CERTIFICATE OF APPROPRIATENESS

Property: 1811 Shearn Street, Tract 9, Block 304, Shearn Subdivision. The property includes a historic 880 square foot, one-story wood frame single-family residence and a detached garage situated on a 3,333 square foot (33'-4" x 100') interior lot.

Proposal: Alteration – Deferral *Revision* - Construct a 1,032 square foot two story addition at the original rear wall of the residence.

HPO File No. 150917

WEST SIDE ELEVATION
EXISTING

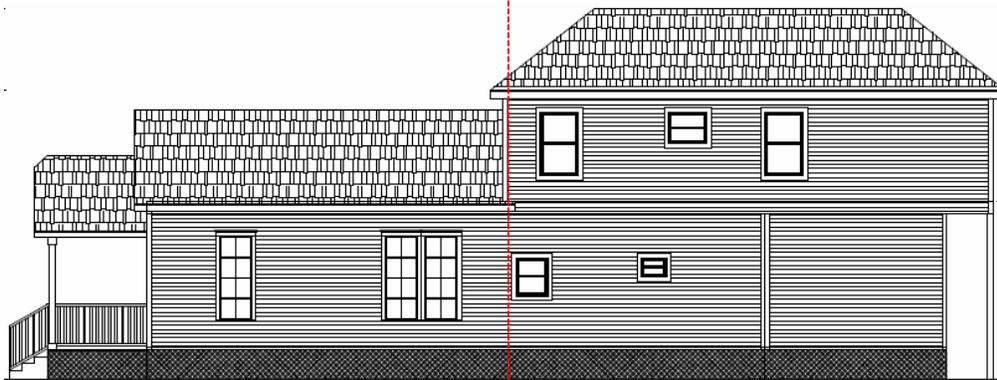
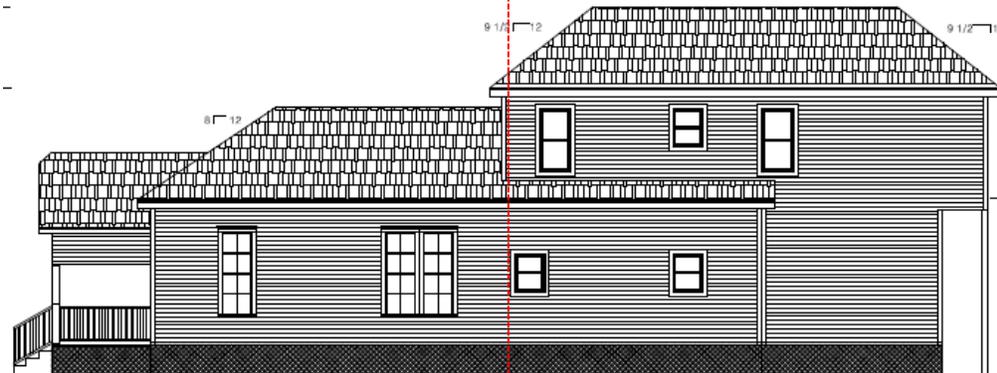
- Clarified that roof shingles are proposed to be used to visually separate the first and second floors of the addition.
- Added taller and narrower windows to the proposed addition.
- Aligned a pair of windows on the first and second floor of both sides of the addition.
- Adjusted the depth of the proposed second floor balcony so that the exterior wall aligns with the corresponding wall of the proposed outdoor kitchen on the first floor when viewed from the west.

Side Elevation: The residence features three original wood windows to be retained. One window in the existing addition will be removed. The proposed addition will feature a door and two windows at the first floor and one window at the second floor.

EAST SIDE ELEVATION

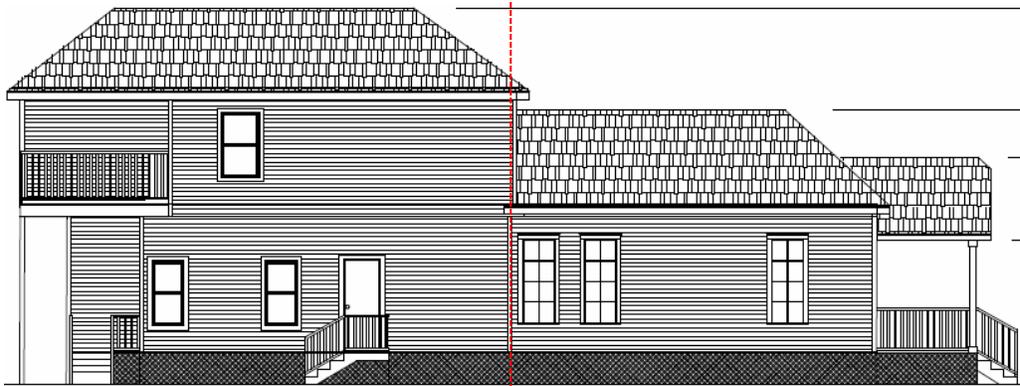
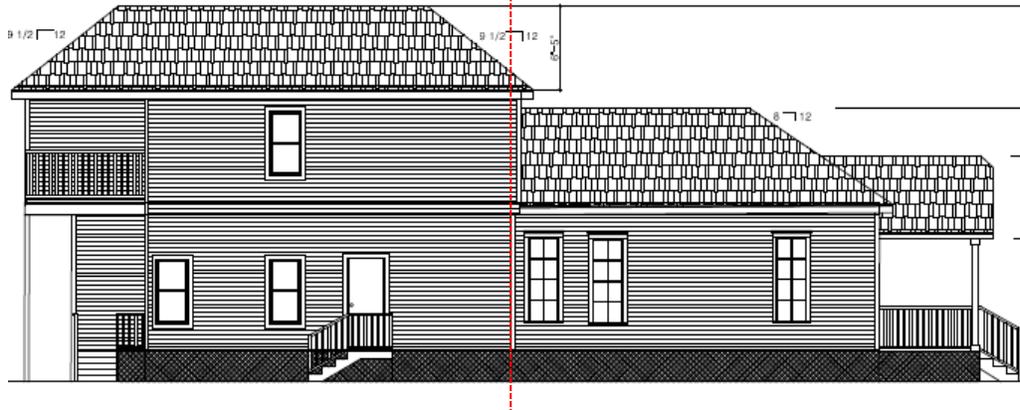
Proposed: Adjusted the window of a the proposed second story game room so that it aligned with a first floor bedroom on the east elevation and aligned a first and second floor bedroom window on the west elevation.

Side Elevation: The residence features three original wood windows to be retained. One existing non-original window will be removed and replaced. A new window will be installed in the existing addition, and the proposed second floor will feature three windows.

SECOND FLOOR PLAN

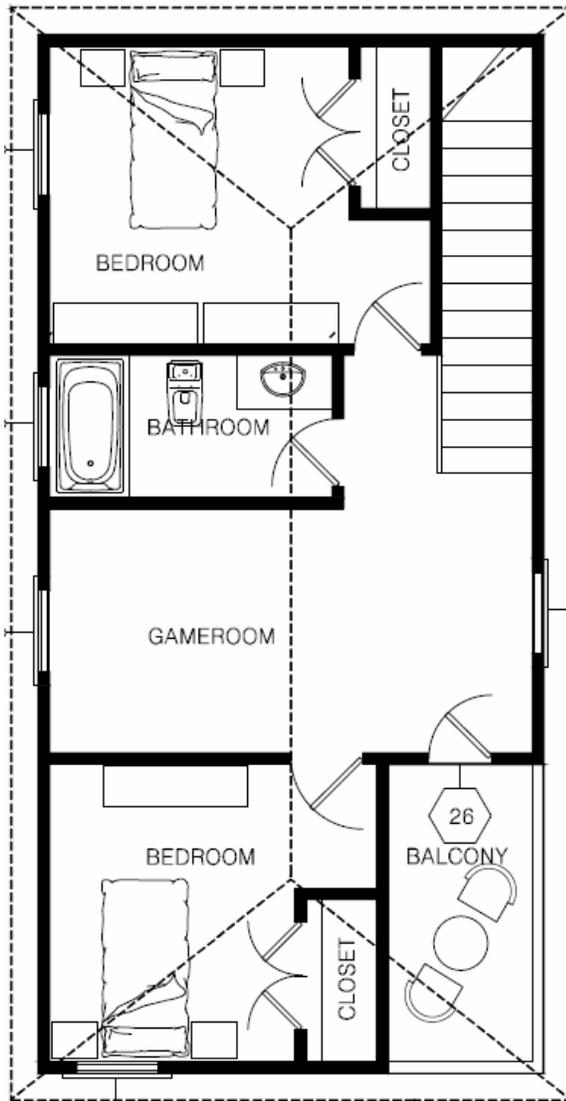
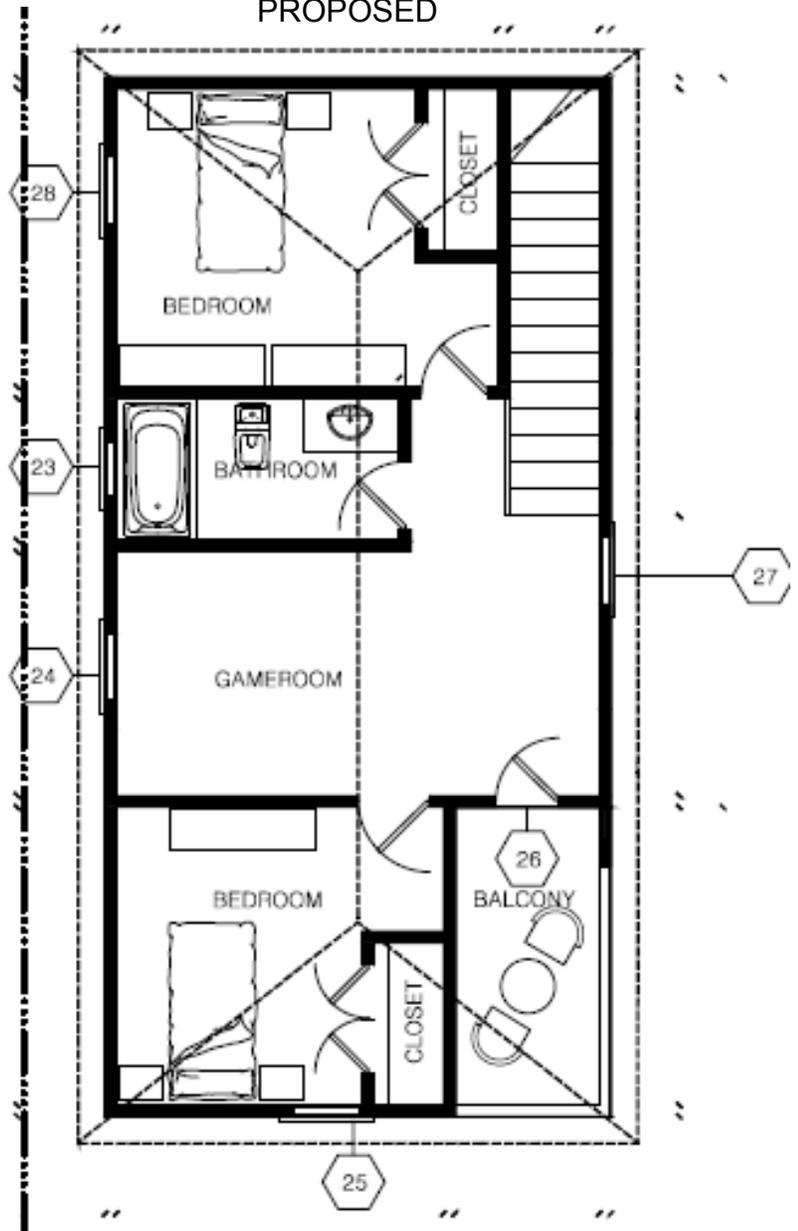
Proposed: The rear wall of the proposed addition's second floor balcony has been adjusted to line up with the rear wall of the proposed outdoor kitchen on the first floor. The applicant has also added a strip of roofing material to delineate the first and second floor of the addition.
